SERVICE INFORMATION LETTER

SIL # 171017-23072-1400WE

SUBJECT: The outer diameter of the heat shrink tubing on the Speed Pickup is too large and causes difficulty during installation into the NHA.

Figure 1, Side-by-Side Image of Speed Pickup Showing Heat Shrink Tubing

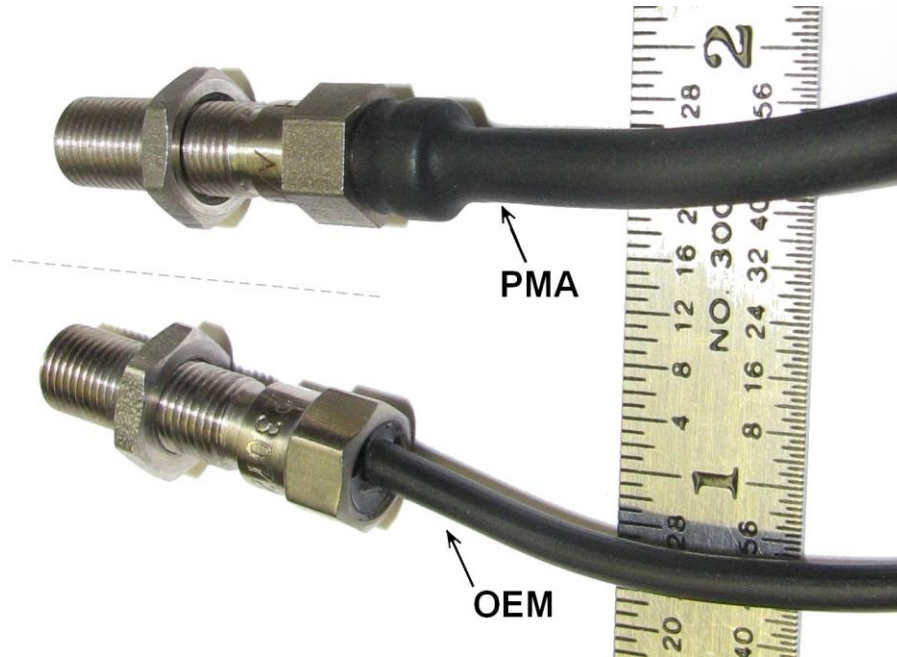
Some customers have complained that the OD size of the heat shrink tubing is causing difficulty installing the Wencor Speed Pickup. The OD size of the Wencor Speed Pickup is approximately 0.175", while the OD size of the OEM is only approximately 0.115". The Speed Pickup wires that are covered by heat shrink tubing must pass through a grommet when installed on the NHA DC Starter-Generator as shown in Figure 3. The larger size heat shrink is more difficult to pass through the grommet.

Any Wencor Speed Pickup Assemblies that are currently uninstalled that have been purchased prior to the date of this SIL may be returned to Wencor for replacement at the discretion of the end user.

However, any Wencor Speed Pickup Assemblies that are currently installed into the NHA, passed the required CMM testing for the NHA and are in service, may remain in service at the discretion of the end user with no risk to normal operation.
